State of Alaska
 Department of Fish and Game
 Nomination for Waters
 Important to Anadromous Fish

Anadromous Water Catalog Number of Waterway 103-25-10150-2019

Name of Waterway Unnamed trib to Deer Creek USGS name ARC# 5858 Local name non-

SUBJECT: Stream Inspection Report
Forest Practices Notification -- STC
Deer Bay Operations
Units 12A and 13B

Area: Deer Bay Land Owner: Sealaska Corporation
Unit no.: 13B Unit Size: 14 Acres Road No.s 6329
Harvest Plan Year: 2000 Date Printed: 06/07/00
Plan submission date: Oct. 1999
Legal: T076S, R084E, Sec. 31

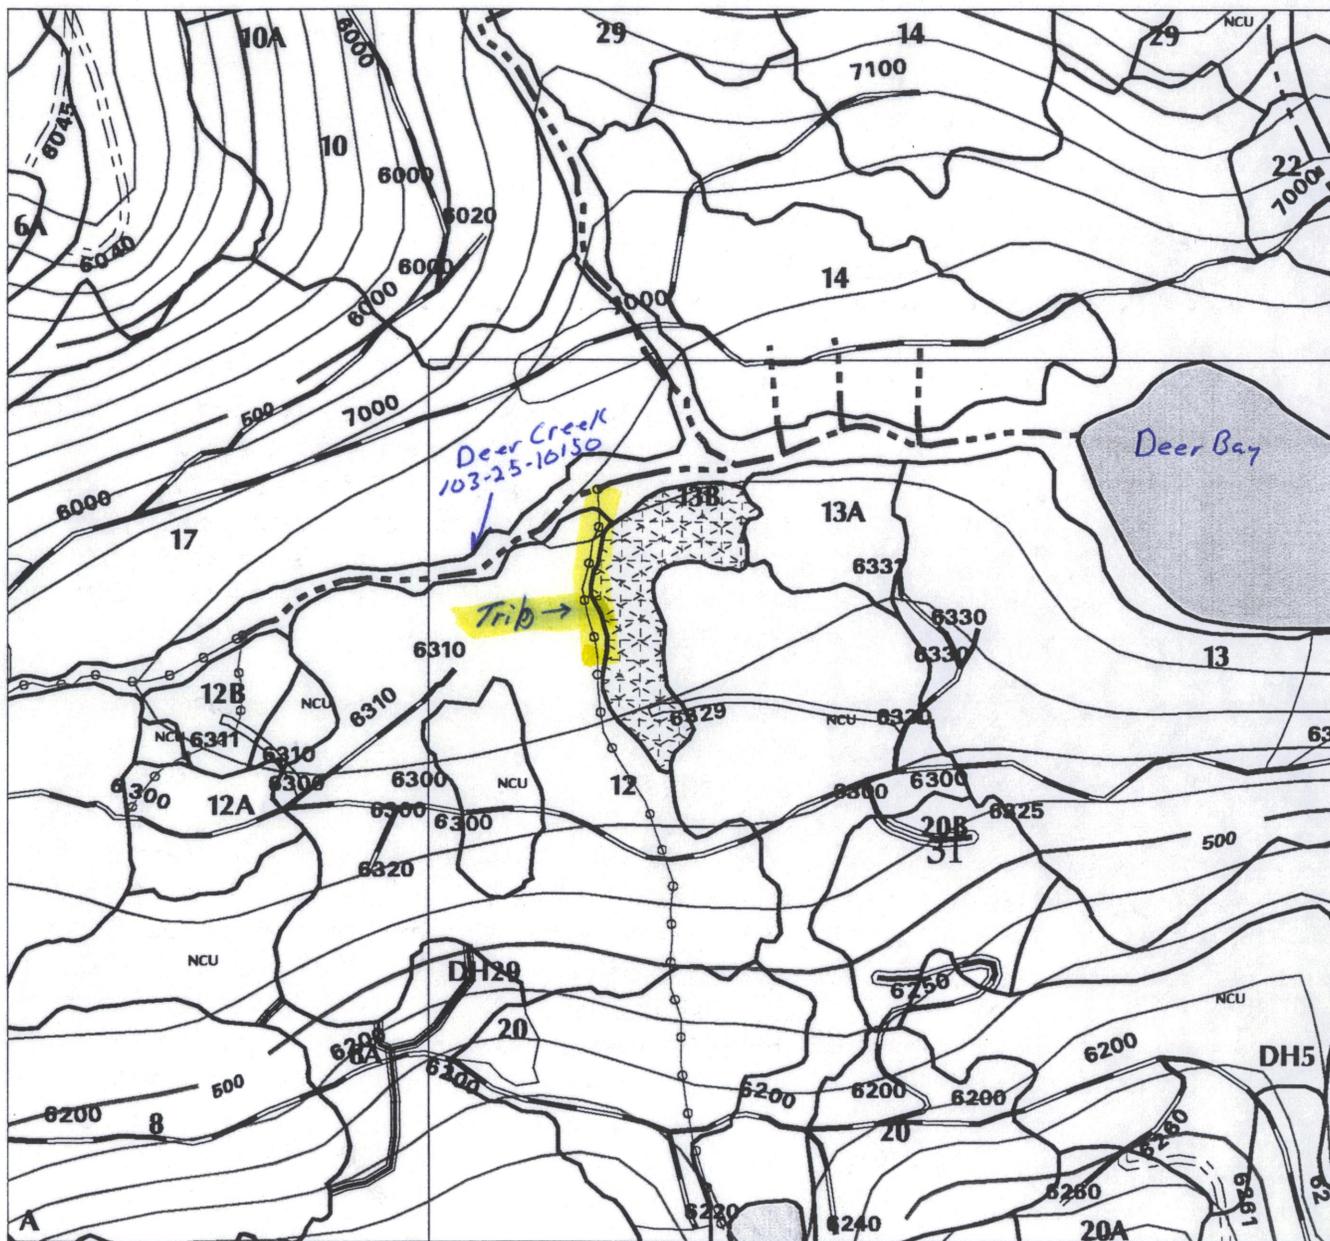
Por M. Manillo
12/16/01
Use Seax map, 1000 ft
marked here, in wrong spot
